SYDNEY CENTRAL CITY PLANNING PANEL

COUNCIL ASSESSMENT REPORT

Panel Reference	PPSSCC-298
DA Number	DA/716/2020
LGA	City of Parramatta Council
Proposed Development	Section 8.3 review of determination for DA/716/2020 for lot consolidation, demolition and construction of a 26 storey mixed-use development comprising 2 retail tenancies on the ground floor, 3 levels of podium car parking comprising 76 car spaces and 108 residential units above. The application is Nominated Integrated development under the provisions of the Water Management Act 2000. The application is to be determined by the Sydney Central City Planning Panel.
Street Address	38-42 East Street, Granville NSW 2142
Applicant/Owner	Toplace Pty Ltd/ G Station Pty Ltd
Date of DA lodgement	28 October 2021
Number of Submissions	One submission
Recommendation	Approval subject to conditions
Regional Development Criteria (Schedule 4A of the EP&A Act)	General Development Over \$30 Million Cost of Construction proposed = \$35,395,865

Figure 4. South-west Elevation of development under subject review application.

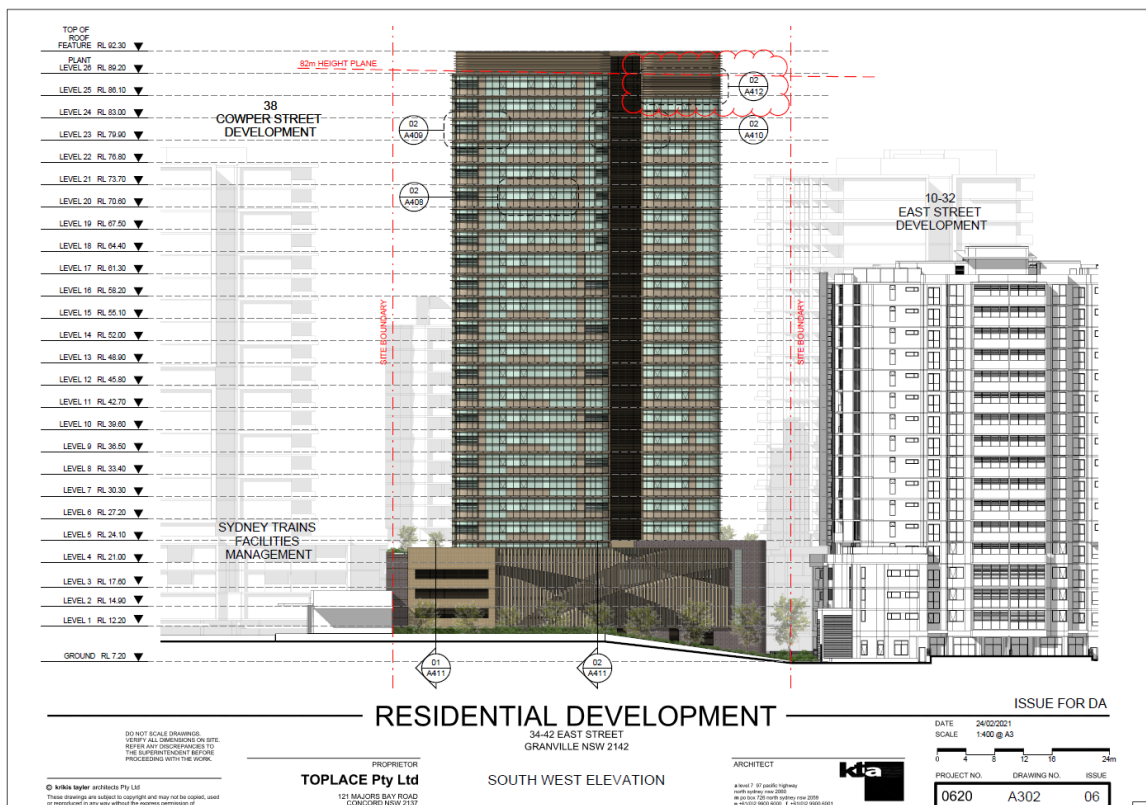
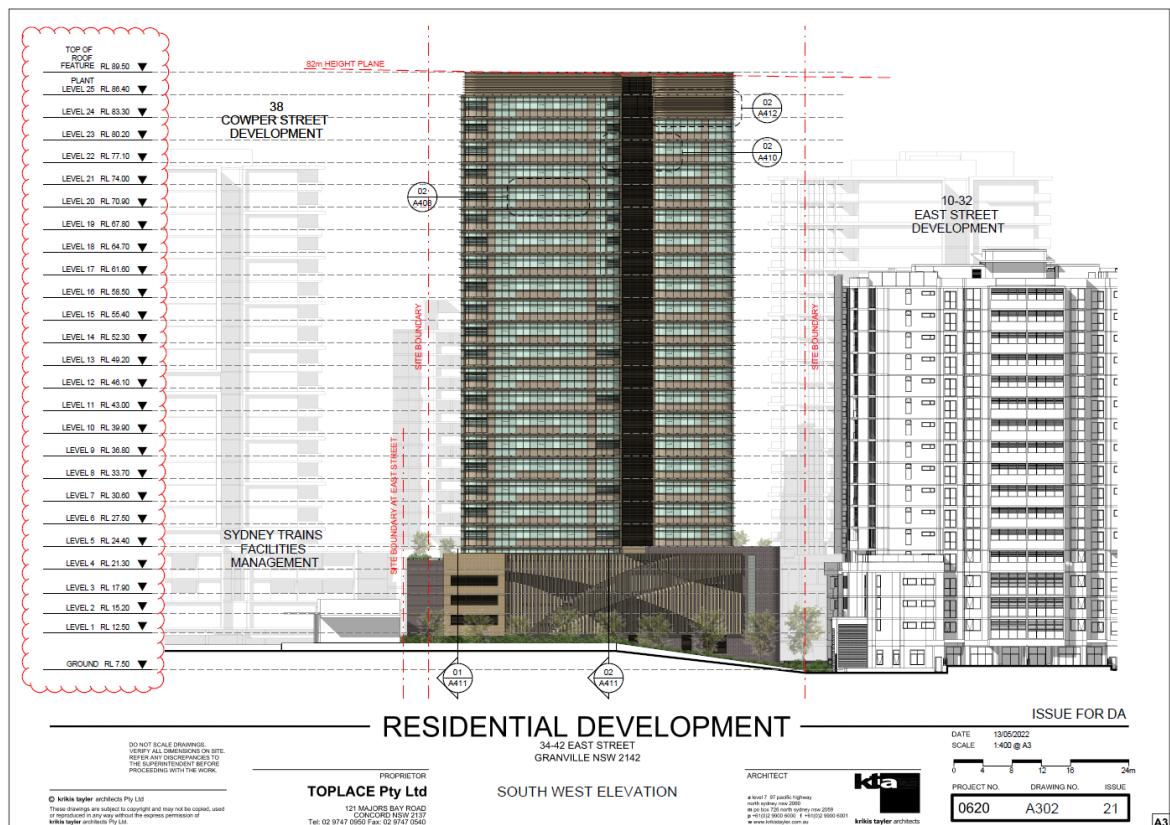
Original Development Application	Review Application	Comment
Building Height = 86.01m	Building Height = 82.66m	The building height has been reduced closer to the maximum height standard. It is noted that the proposal still exceeds the maximum building height, and a variation is sought under Clause 4.6 of LEP 2011.
Gross Floor Area = 10,277m ²	Gross Floor Area = 8,968m ²	<p>The Gross Floor Area (GFA) has been reduced through the reduction in the number of apartments and some retail area.</p> <p>It is noted that the original assessment report identified an inadequate survey plan and resulting incorrect site area calculations.</p> <p>A correct survey plan and revised site area calculations were submitted with this review application. The Gross Floor Area complies with the maximum FSR for the site.</p>
Retail Floor Area = 257m ²	Retail Floor Area = 253m ²	The retail floor area is slightly reduced.

Number of storeys = 26	Number of storeys = 26	No change.
Car parking = 86 spaces over three podium levels	Car parking = 76 spaces over three podium levels	The number of car parking spaces has been reduced.
114 residential units: - 22 x 1 bedroom, 83 x 2 bedroom and 9 x 3 bedroom	108 residential units: - 19 x 1 bedroom, 80 x 2 bedroom and 9 x 3 bedroom	The number of 1 bedroom and 2 bedroom apartments have been reduced.

The proposal as amended is substantially the same development; being demolition, tree removal and construction of a 26 storey mixed use development.
